Bramford to Twinstead Reinforcement

Document 7.3.4 (B): Draft Statement of Common Ground National Highways

Final Issue B
October 2023

Figure 7 - Construction Traffic Flow Diagram (Sheet 1)
 Bramford to Twinstead Reinforcement
 AM Peak: 0800 - 0900

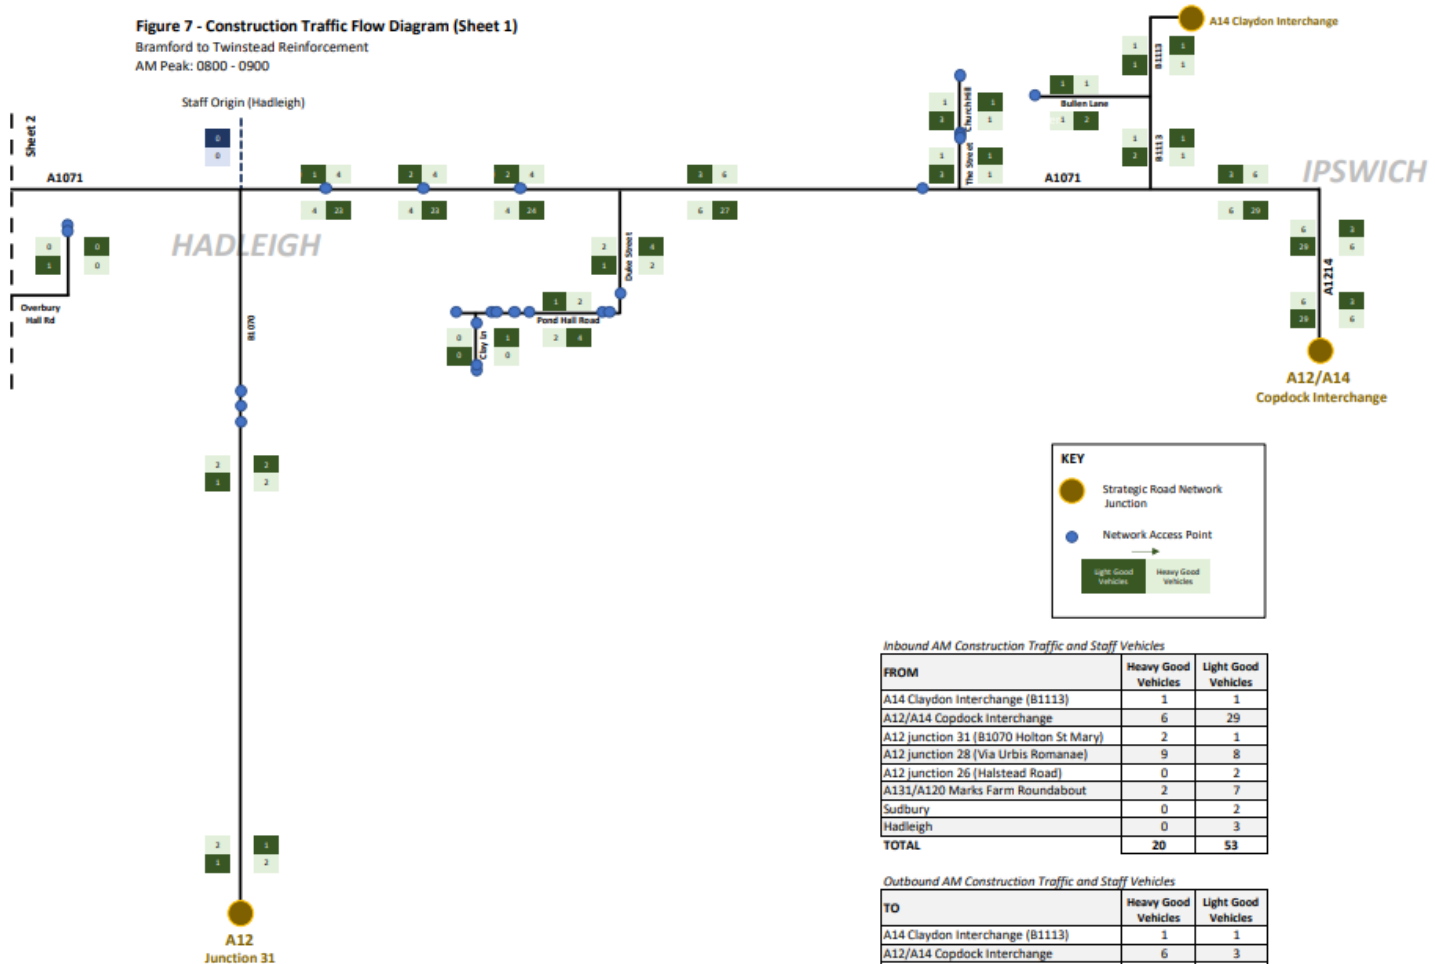
A1. This Note responds to a statement by the Consultee that they would expect to see an assessment of the impact of the construction traffic on the junctions where the construction traffic joins the strategic road network (SRN).

A4. An assessment of the impact of project construction traffic on the SRN has been undertaken. Full details are provided in the Transport Assessment [APP-061]. Figure 7 in the Transport Assessment (see image on next page) indicates that the junctions on the SRN that are expected to carry the highest volume of project construction traffic are:

- The A12/A14/A1214 Copdock junction – during peak construction activity, the A1214 approach arm is forecast to carry an additional 35 vehicles northbound and 9 vehicles southbound in the AM peak hour (0800-0900) – the same volumes would be expected in the PM peak hour (1600-1700) with the direction reversed.
- The A12 junction 28 – during peak construction activity, the Via Urbis Romanae approach arm is forecast to carry an additional 17 vehicles northbound and 17 vehicles southbound in both the AM peak hour (0800-0900) and the PM peak hour (1600-1700).

A5. The impact at the other four SRN junctions expected to carry project construction traffic (A14 Claydon Interchange, A12 junction 26, A12 junction 31, and the A131/120 Marks Farm Roundabout) would be less than 10 vehicles in any direction in either the AM or PM peak hour during peak construction activity.

A6. When considered as a percentage of existing traffic, the Transport Assessment shows that for HGV, the percentage increase on these sections of the A12 and A120 would be approximately 4% for the peak periods, which is within the normal parameters for traffic variation range at a SRN junction, when preparing sensitivity test.

A7. The forecasts summarised above include a significant level of contingency. For example, as set out in paragraphs 6.2.8 and 6.2.9 of the Transport Assessment, August 2025 was identified as the overall peak month for construction traffic generation, but the peak monthly forecast at each Access Point (AP) in a seven-month period centred on August 2025 was used to generate a traffic forecast for the Transport Assessment for both construction vehicles and staff vehicles. This was to account for any programme movements that would align peak activity at different APs and resulted in a significant uplift in the forecast used in the Transport Assessment. For example, the peak daily on-site staff estimate for the whole project in August 2025 is 350, but the result of the seven-month review meant that the Transport Assessment assumes 528 staff are on-site during a peak day – this is a 51% uplift in expected peak staff numbers for the purposes of assessment.

A10. Therefore, the project would have negligible impacts upon the operation of the SRN during the project construction and hence the risk assessments are not necessary.

A11. Therefore, a robust worst-case assessment of project impacts on SRN junctions has been undertaken. Given the low numbers of vehicles expected to use SRN junctions during periods of peak construction activity, the significant contingency added to the forecast, and the temporary nature of construction traffic generation, it is the view of the Applicant that the project would not have a substantial impact upon the operation of the SRN during construction and that it would be disproportionate to undertake further assessment of any of the impacted junctions.
